Technical Bulletin

Model: Finisher for the AD3			Date	e: 31-July-97	No: 1
Subject: ROM modification for Main Control Board				Prepared by: E.	Fukuyama
From: QAC 2nd I	Field Information Dept.				
Classification:	☐ Troubleshooting	☐ Part informat		tion	n required
	☐ Mechanical	☐ Electric	al	☐ Serv	ice manual revision
	☐ Paper path	☐ Transmit/rec		eive	ofit information
	Other ()

Model: Finisher for the AD3		Date: 30-Sep-97		97	No: 18	
Subject: SC101				Prepared by: E.Fukuyama		
From: QAC 2nd Field Information Dept.						
Classification:	☐ Troubleshooting	Part informat		_		•
	☐ Mechanical	Electrical		☐ Service r		ce manual revision
	☐ Paper path	☐ Transmit/rec		ceive Retrot		fit information
	Other ()

New Entrance Guide

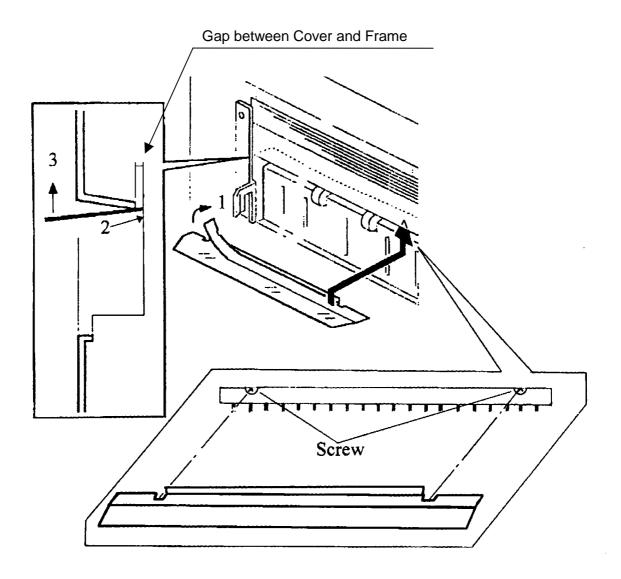
For the machines on which the Finisher is installed, if a large amount of copies is made right after power-up, SC101 may occur. If SC101 occurs, please replace the Entrance Guide with part number A6122333. The installation procedure for the Entrance Guide is shown on the next page.

If the Entrance Guide is not installed in the proper position, a gap may develop between the Cover and the Main Frame through which the heat and humidity generated by the paper may enter and lead to high temperature/high humidity around the lamp stabilizer.

MB#8 and MB#9 provide information concerning the change in shape of the Entrance Guide. Please refer to these MBs for further details concerning this modification.

During the set-up of a Finisher manufactured after May 1997, please install the Entrance Guide in a manner that will prevent a gap from developing between the Cover and the Main Frame. Please refer to the attached page for this procedure.

In the event of an SC101 on a Finisher manufactured before April 1997, please replace the Entrance Guide with part number A6122333.

- 1. Peel off the tape seal for the Entrance Guide
- 2. Place the Entrance Guide on the Main Frame.
- 3. Attach the Entrance Guide to the Cover
